DRAFT ADDENDUM NO. 1

Proj. No.: CSE2201

Subject: Wallbrook Development
Gravity Sewer Capacity Evaluation

Wallbrook Offsite Utility Improvements

Figure 4
Capacity of Existing and Upsized Downstream Gravity Sewer at Q2-2026

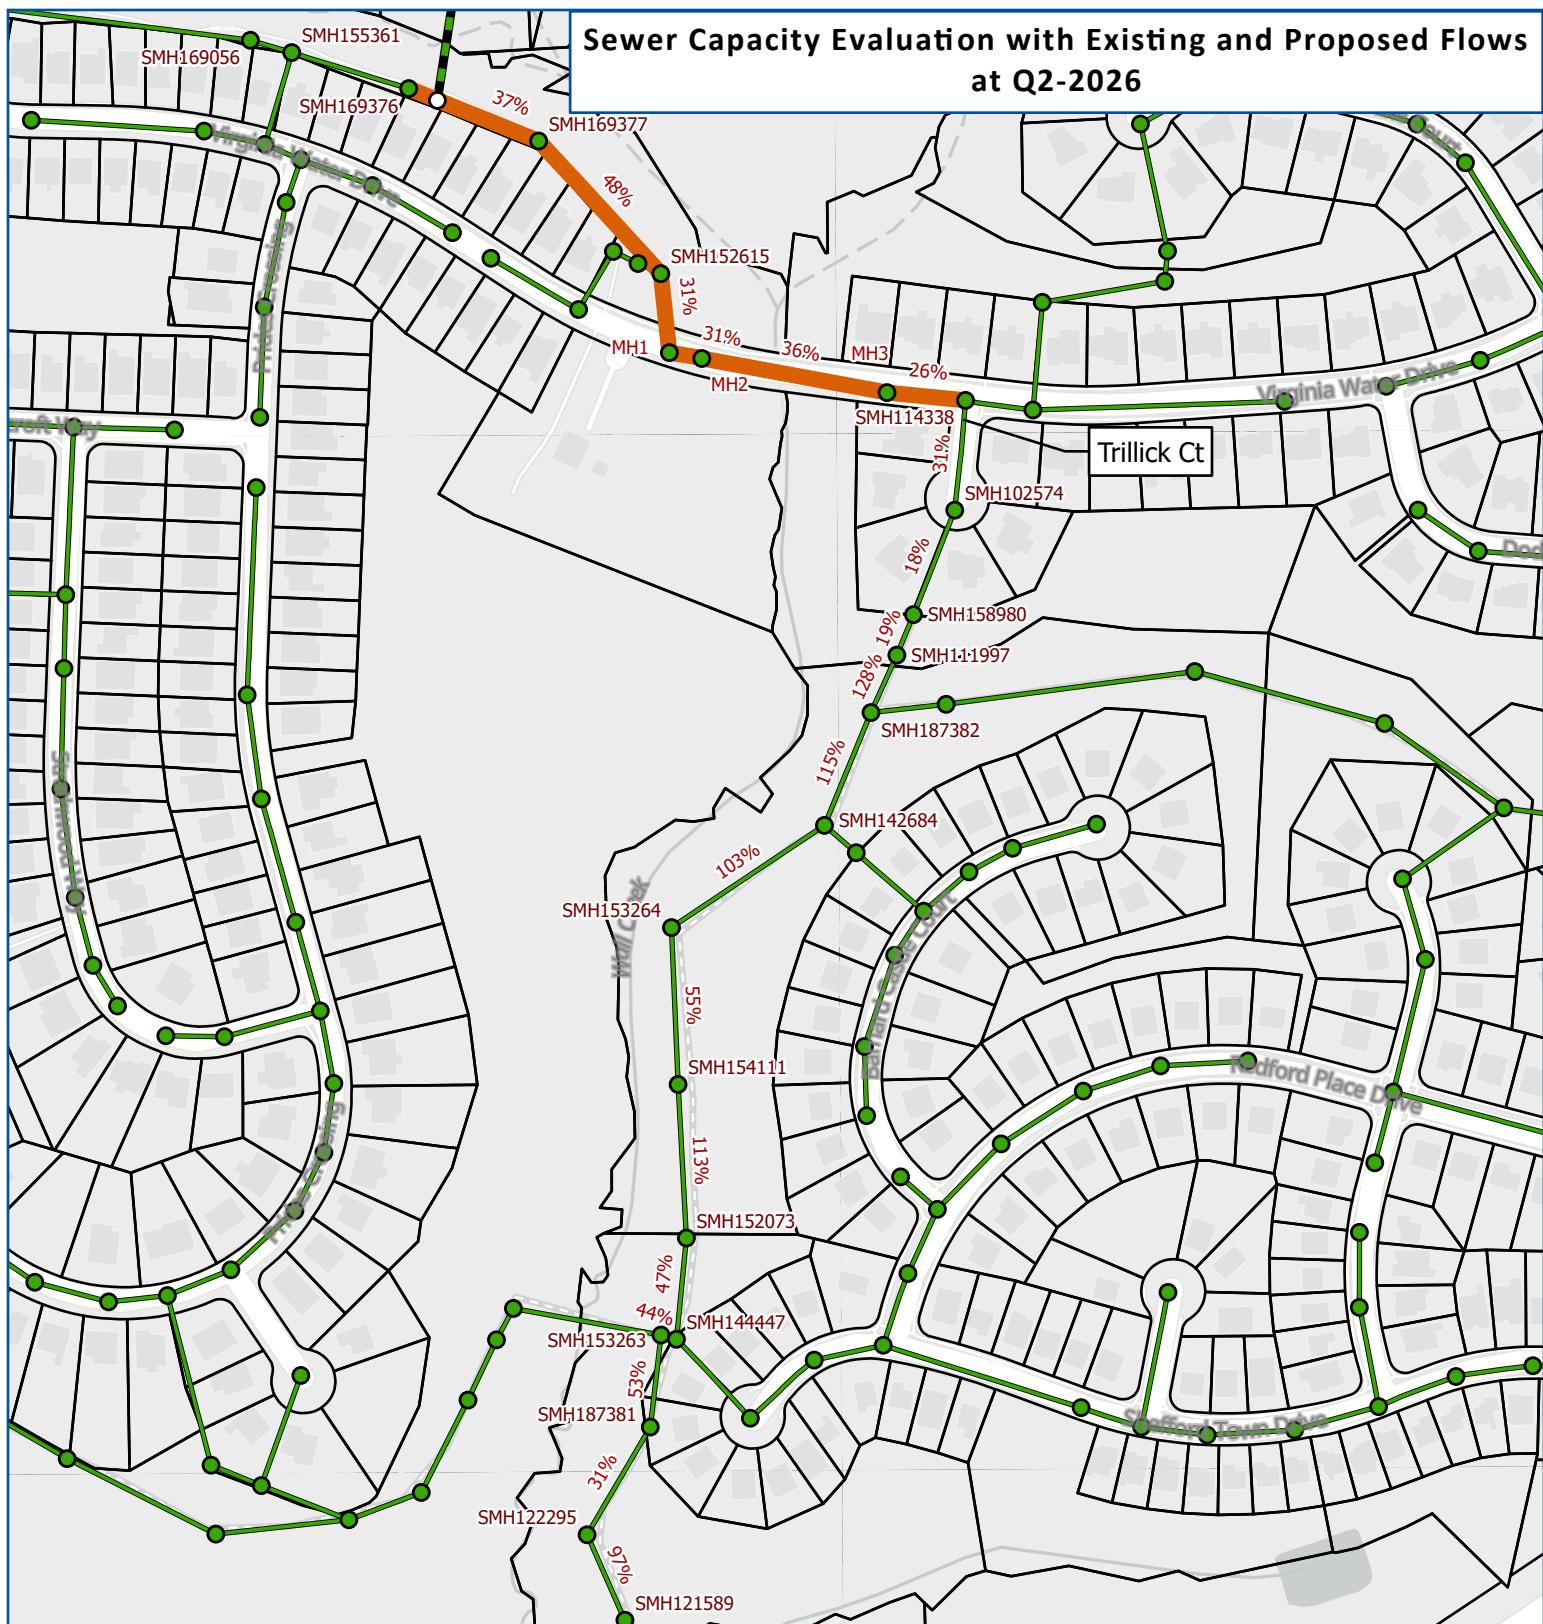
Downstream of Trillick Court, there are four (4) sewer segments over 100% capacity at the end of Q2-2026. Table 2.1 illustrates the capacities of these segment throughout the evaluation period. Figure 4 shows the capacities in the pipes at the end of the evaluation period.

1-All wastewater flows from Wallbrook are included and the Willow Crest PS wastewater flows are removed.

Therefore, Raleigh Water directed HIGHFILL and the Wallbrook Development team to remove the sewer upsize south of Trillick Court from the Offsite Sewer Improvements. Raleigh Water asked for a capacity evaluation based on the timeline of wastewater flow generation from the Wallbrook Development and the Willow Creek PS wastewater flow being redirected to the Sanford Creek Sewer Outfall.
